**ASHLAND PLANNING DIVISION**  
**PRE-APPLICATION CONFERENCE**  
**COMMENT SHEET** December 11, 2024

**SITE:** 223 W Hersey  
**APPLICANT:** Derek Sherrell  
**REQUEST:** Land Partition

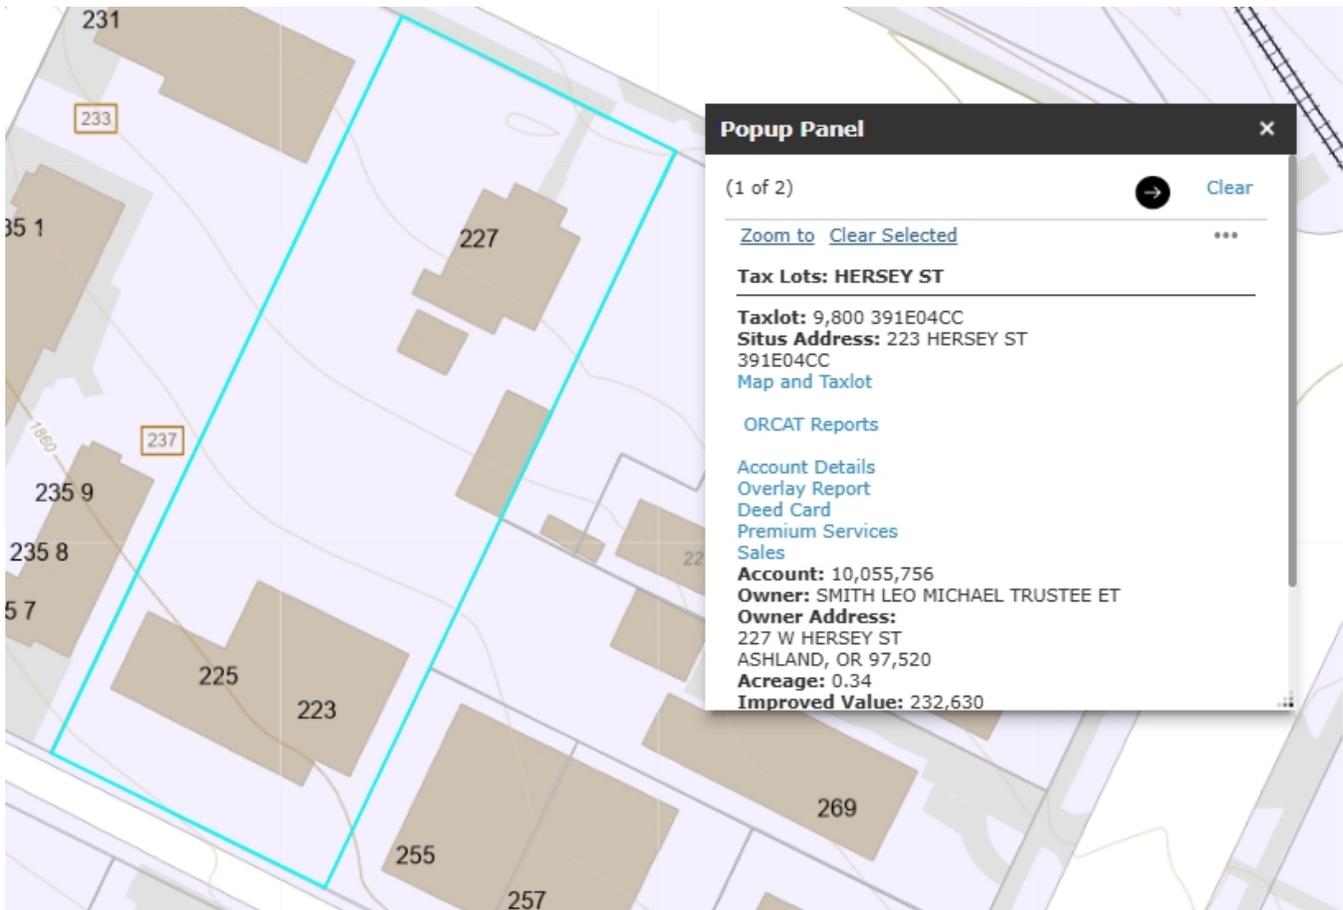
The application is a very straight forward partition. If the desire is to ultimately further subdivide the property the applicant may want to consider pursuing a PSO subdivision instead of a partition as the partition proposal may foreclose on other opportunities going forward, for instance alley access or parking.

For staff the primary concerns are ensuring that the partition does not prevent the property from being able to develop to at least 80% of the base density.

- Property owner must be applicant, or authorized agent
- The property is zoned R-3 and is 0.34 acres in size. The allowed density for the R-3 zone is 20 dwellings per acre. Calculated base density =  $0.34 \times 20 = 6.8$

- The property is presently developed with a single-family home and a duplex. Therefore the development potential is three additional units.
  - Minimum required density is 80% of the calculated density ~ 5.44 dwellings. An application shall demonstrate that the proposal doesn't limit the development below 5.

- The proposed 8,030 sq ft. parcel will have a calculated base density of  $0.1843 \text{ ac} \times 20 = 3.68$ .
  - Only two additional units could be built after the partition. {The partition is reducing the possible development potential.}

- Will not be eligible for MHL, but PSO subdivision is possible [although not required].
- Future development may require that existing non-conforming driveway to be addressed and or relocated.

- There appears to be a water meter at the alley serving the duplex, as well along the street frontage for the main home.
- Development of an additional home on the new parcel would be approved consistent with duplex standards. The development of two new homes would require Site Design Review.

- Complete Frontage improvements including sidewalk and street trees will be required.
- Paved pedestrian access to the rear lot will be required.
- The SITUS address for the property appears to be 223 which is one of the duplex units, and

**Scalable Plans:** The plans submitted for the pre-application conference are not to scale. Scalable plans are required for the application to be deemed complete.
